ADDENDUM NO. 3

November 11, 2022

LIBERTY ELEMENTARY SCHOOL RENOVATIONS Chesterton, IN 46304

DRAWING
**FOODSERVICE EQUIPMENT
PLAN AND SCHEDULE**

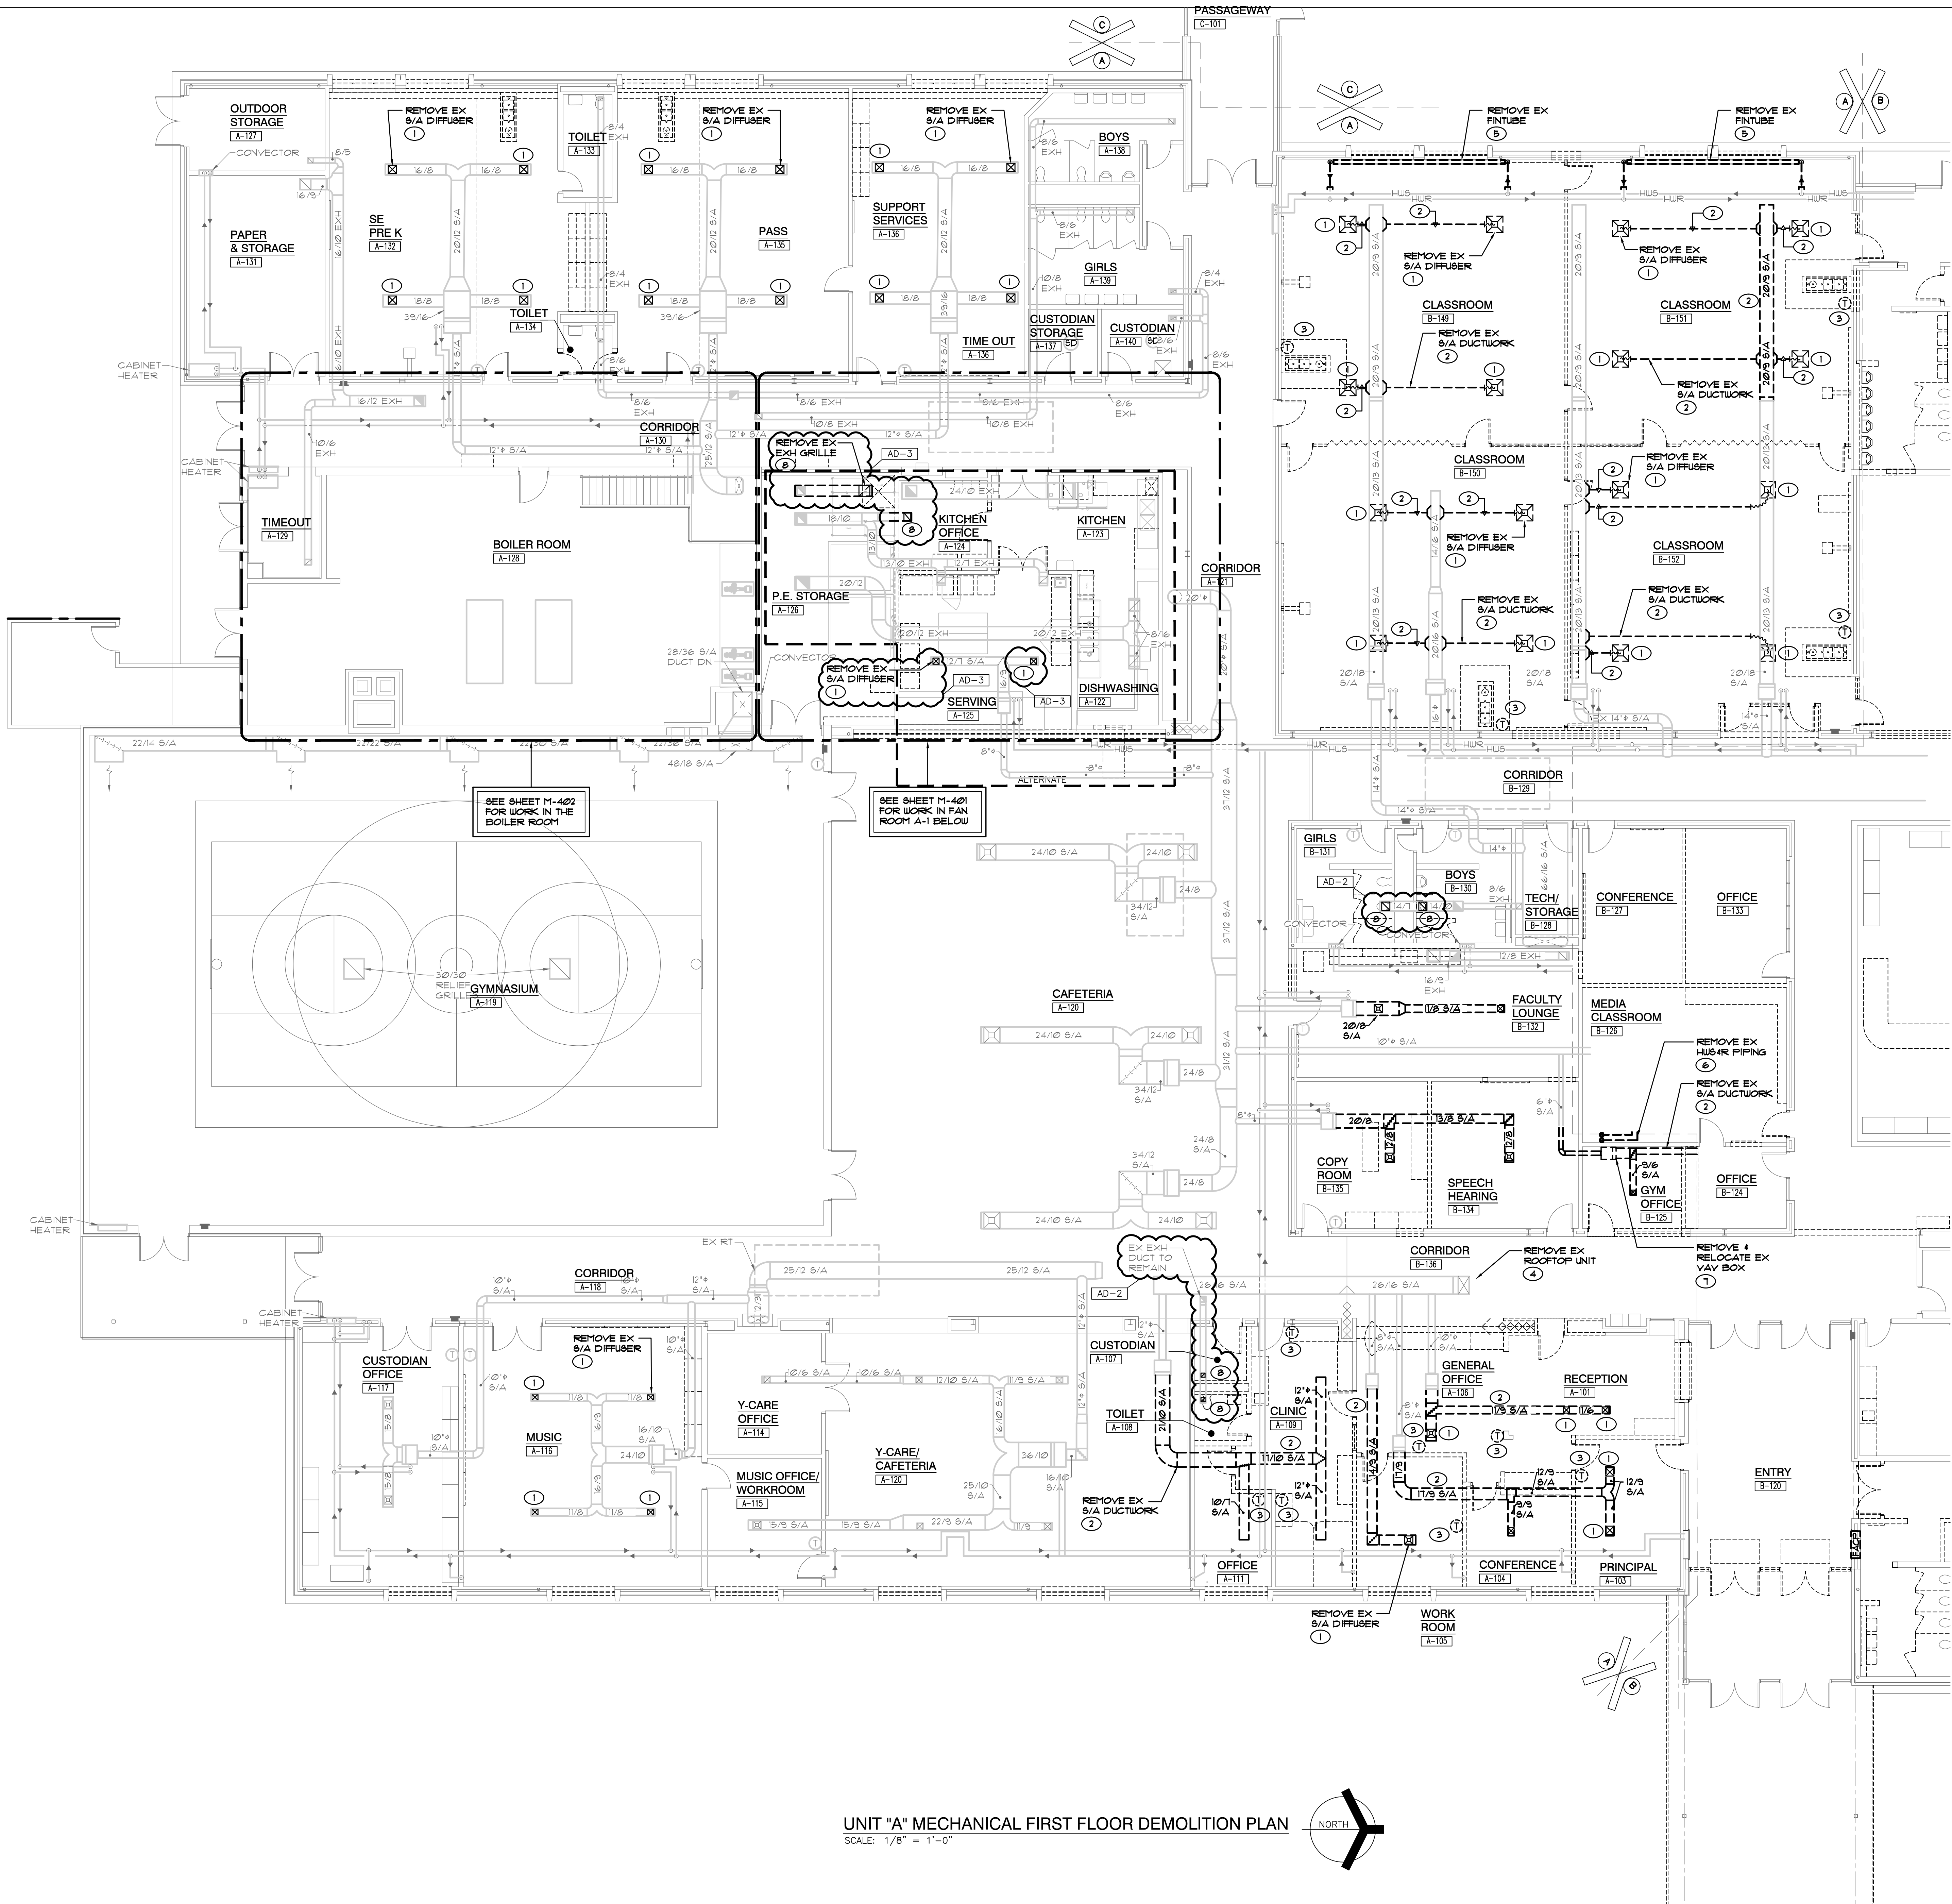
- A. Refer to revised full size drawing, included in this Addendum, for revisions.

UNIT "B" ELECTRICAL FIRST FLOOR DEMOLITION PLAN

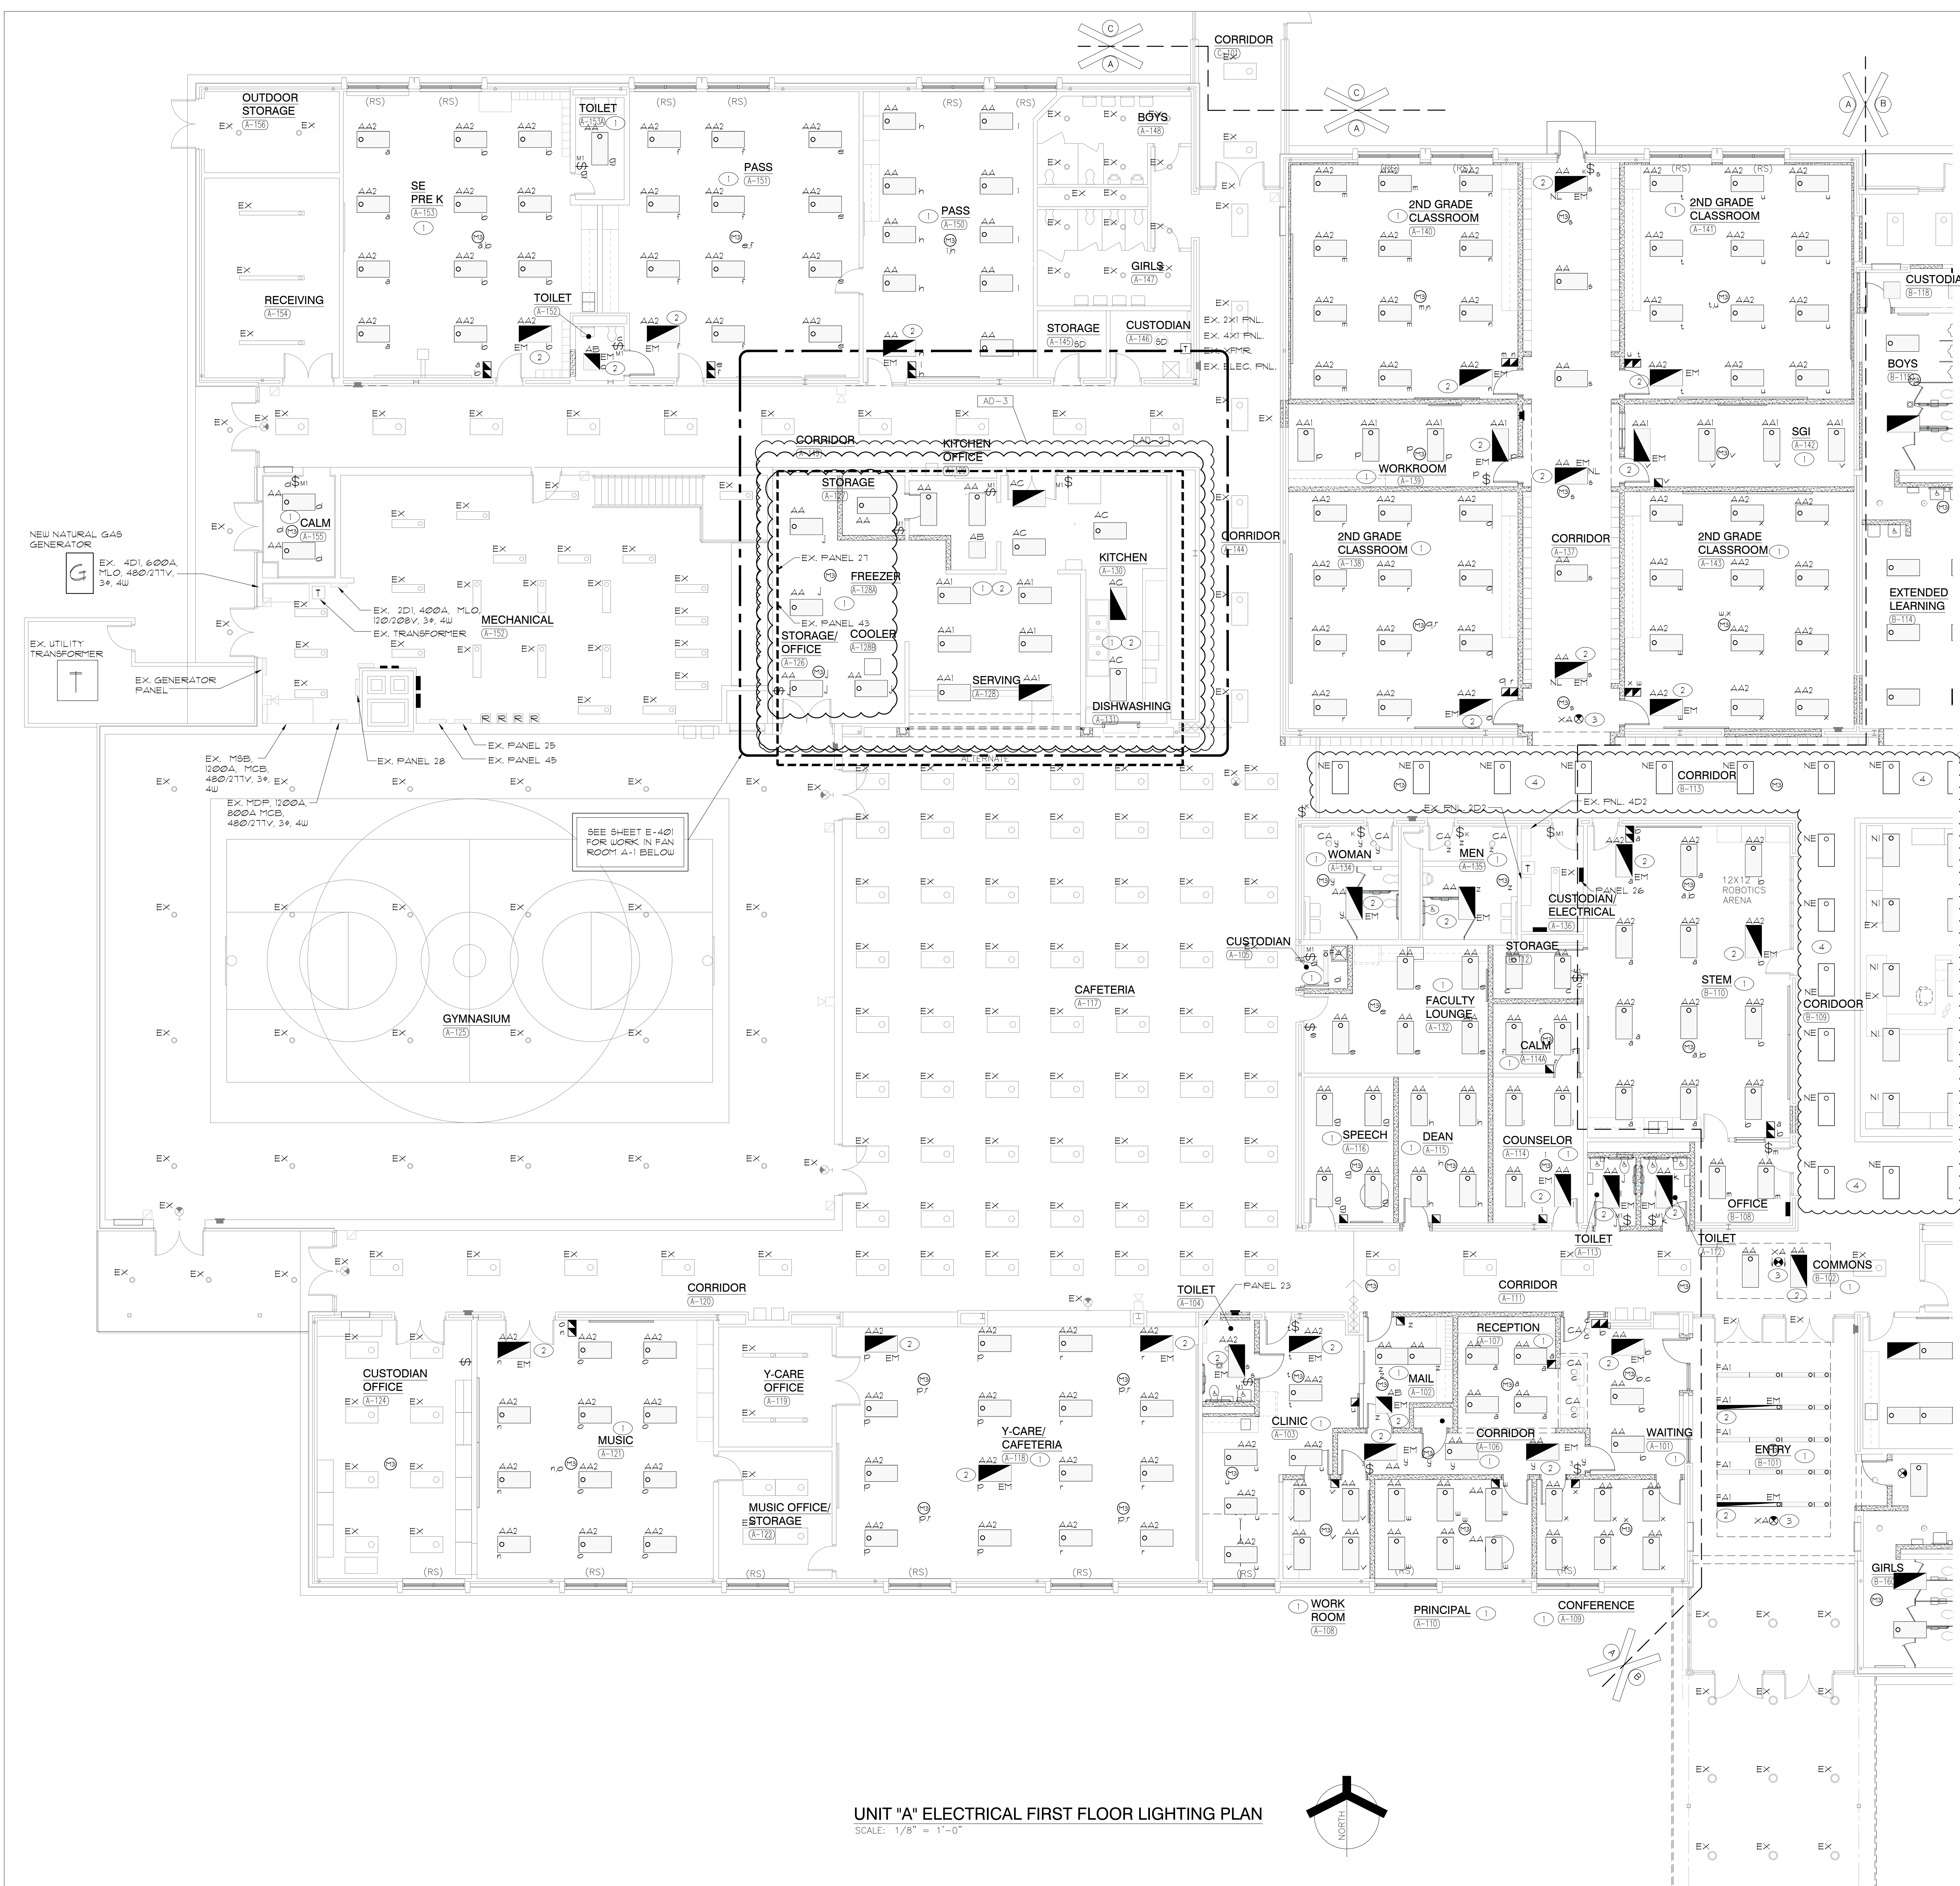
- A. Refer to two (2) revised full size drawings, included in this Addendum, for existing lighting demolition revised in Media Center.

UNIT "A" ELECTRICAL FIRST FLOOR LIGHTING PLAN
SCALE: 1/8" = 1'-0"

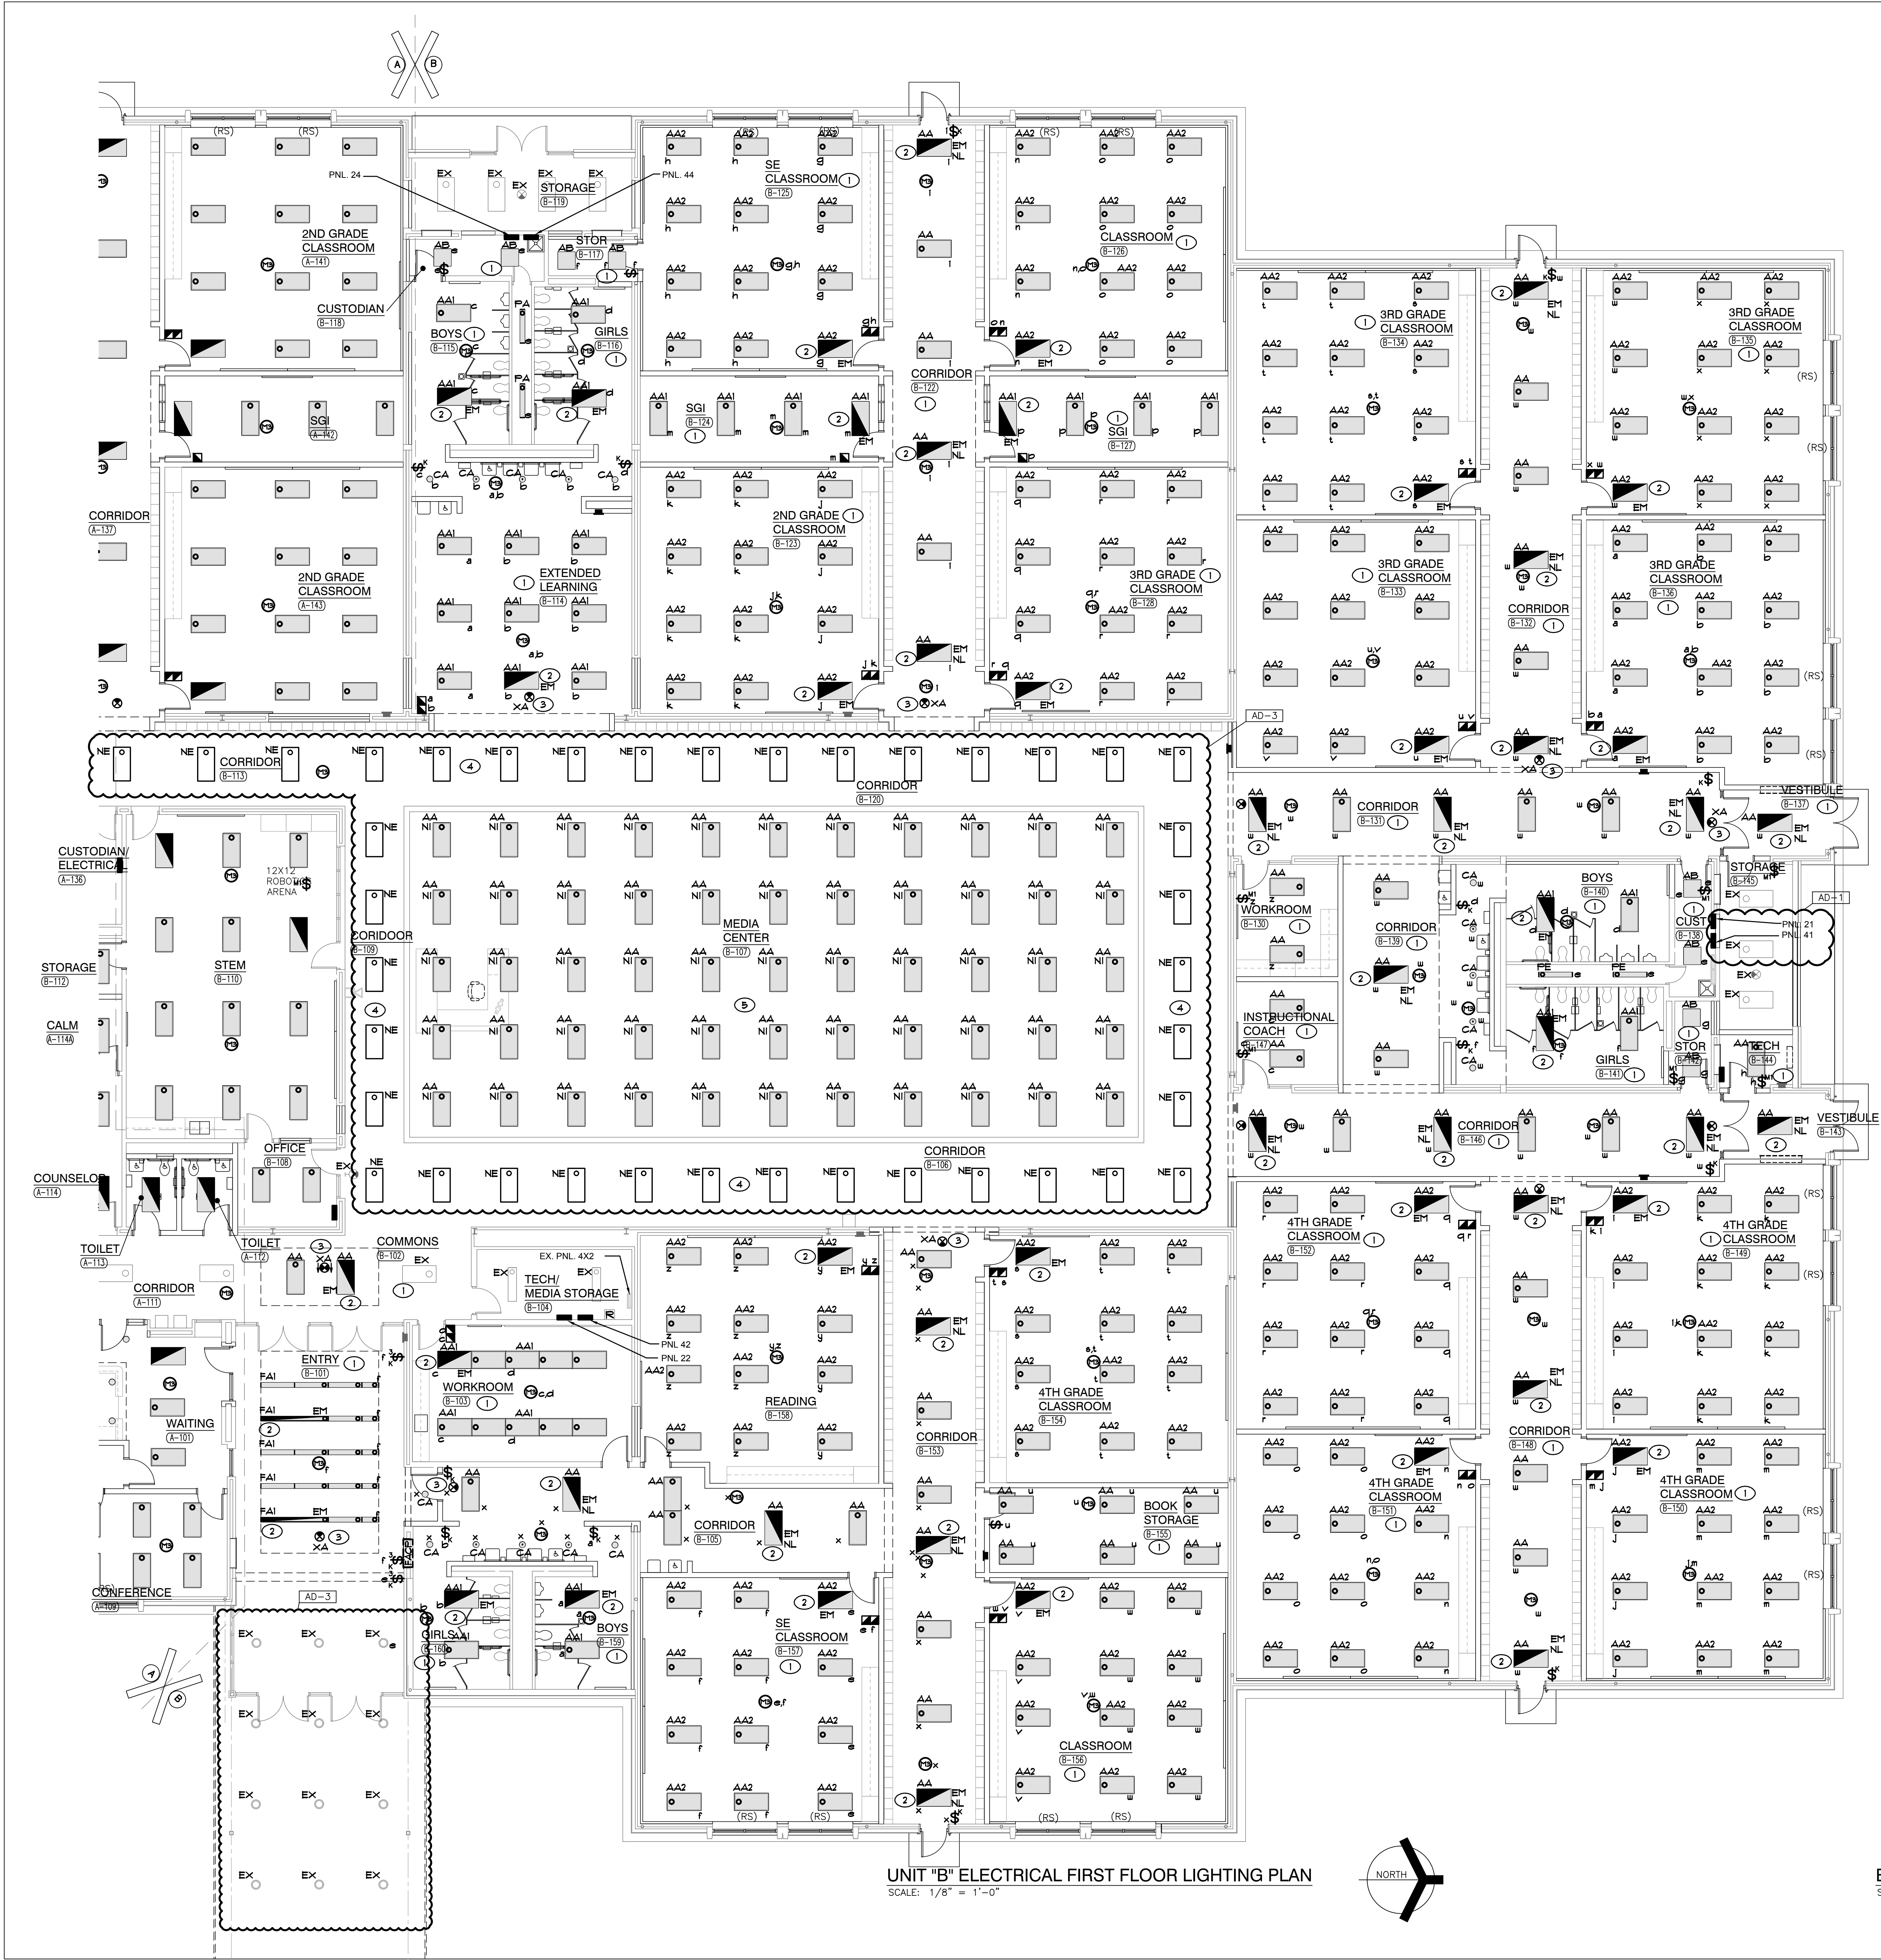
- A. Refer to two (2) revised full size drawings, included in this Addendum, for existing lighting replaced in Media Center.
